This document summarizes the changes between the previous ASI4U silicon revision C and the current silicon revision E. These include requested UART design changes. The purpose of the redesign was to correct reported timing errors by the UART in the following modes: Master, Monitor, and Repeater. A problem with slave communication in special network constellations was also fixed.

Figure 2.1 Comparison of Valid MAN-Code Signal to Faulty MAN-Code Signal

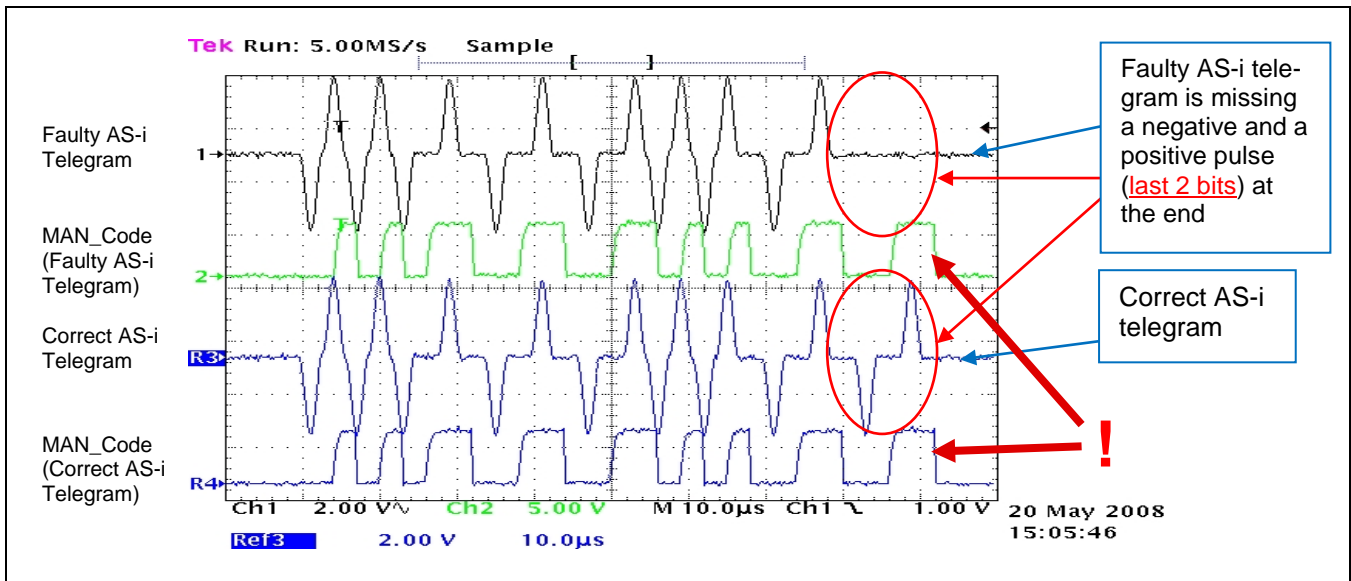
If the ASI4U revision C operates in Master Mode, Monitor Mode or Repeater Mode, the error signaling for an *End_Bit_Error* does not work correctly. In some special cases, the generated MAN-Code of a signal with an *End_Bit_Error* looks similar to the MAN-Code of a signal without any errors as demonstrated in Figure 2.1.

This malfunction of the ASI4U revision C results in an MAN-coded output signal that does not allow distinction between correct AS-I pulse sequences and pulse sequences that are shortened (missing one negative and one positive pulse). It occurs only under the following conditions:

- The parity of the signal is even.
- The last bit of the corrupt telegram is equal to binary 1.
- The *Stop_Bit* and the *Parity_Bit* or the *Start_Bit* and the *Control_Bit* are missing.
- If the *Start_Bit* and the *Control_Bit* are missing, the first pulse must have a negative polarity.

The following changes in the UART block were implemented in ASI4U silicon revision E:

1. The last pulse of the MAN-coded LED1 output signal is now always kept in ACTIVE state for 9 μ s if an ASI telegram with an *Endbit_error* is received.

The polarity of the ACTIVE State depends on the signal setting at the DI ports in Master Mode, Monitor Mode, and Repeater Mode. If DI2 and DI3 are driven by equal input signals, the MAN output signal at LED1 is configured ACTIVE LOW. If DI2 and DI3 are driven by unequal input signals, LED1 becomes inverted and is configured ACTIVE HIGH.

Since a 9 μ s-wide MAN pulse is an out-of-specification event for the AS-I MAN signal, it will allow the connected microcontroller to recognize the error in the AS-I pulse signal on the AS-I line.

Figure 3.1 Test for ASI4U Revision C Error in Master Pause Detection

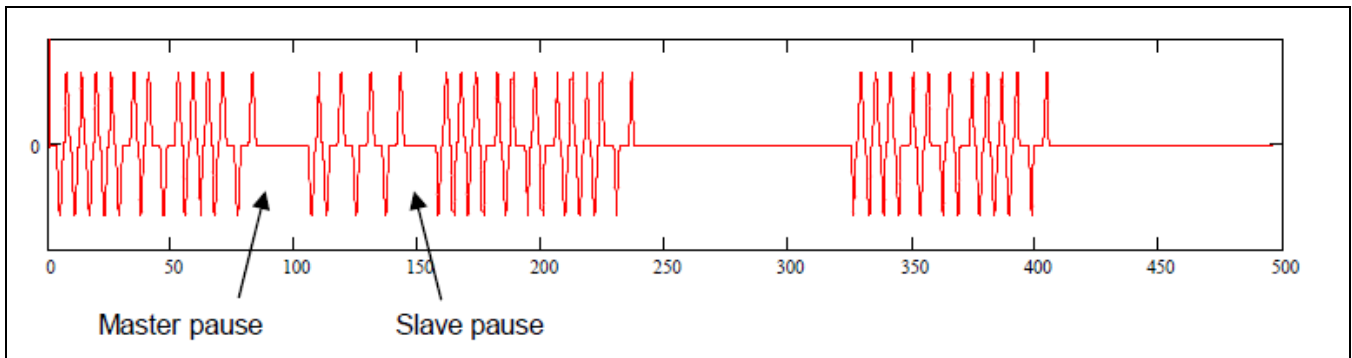
If the previous ASI4U revision C is operated in Slave Mode, the UART Master Pause detection does not always function correctly when the UART must listen to slave responses from a different slave. Depending on the actual AS-I line pulse timing, a slave response from a different slave is sometimes not recognized correctly, which results in a UART communication error. This prevents the Slave from understanding the next Master telegram correctly. If the Master telegram addresses the Slave itself, the error leads to a missing slave response and the Slave replies on a second repetition of the Master Call to its own address in asynchronous mode.

Figure 3.1 shows a telegram test case to reproduce the error. The AS-I signals shown in Figure 3.1 were generated by a signal generator that allowed sweeping the Master Pause and Slave Pause duration over the allowed specification limit. The first Master Call contains a different slave address than the tested slave. The second and third master calls address the tested slave. The tested slave replied with the erroneous behavior for certain Master pause and Slave pause scenarios only. The majority of the test cases were passed without error.

A new principle of AS-i telegram pause detection was implemented in ASI4U silicon revision E that is more precise and able to cover all valid timing scenarios for Master and Slave pauses. The new principle is now independent of the internal timing constraints of the UART state machine.
